February 12, 2019

RE: **Lot 3 Block 3 Unit 22 SAD 228**
7912 Aguila St. NW
Volcano Cliffs Subdivision
Grading and Drainage Plan
Engineers Stamp Date 2/7/19 (D10D003I5)

ENGINEER'S SEAL	Title 7912 Aguila St. NW GRADING AND DRAINAGE PLAN	DRAWN BY
		DATE
2-07-19	<i>RHD Engineering, LLC</i> 4305 Purple Sage Ave. NW ALBUQUERQUE, NM 87120 (505) 288-1621	Day SHEET # 1 of 1
Richard Dourte P.E. #10854		JOB #

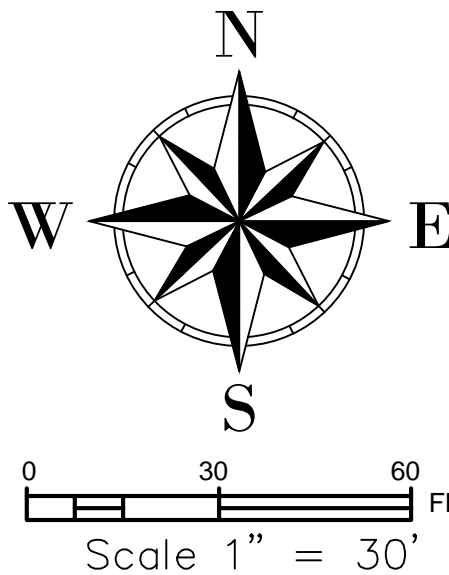
Reiterate to the Owner/Contractor that a separate permit for a garden/retaining wall must be obtained, with the approved G&D plan.

Prior to building permit approval a pad certification will be required. Place this statement on the plans under the general notes

Prior to Certificate of Occupancy release, Engineer Certification per the DPM checklist of this plan will be required.
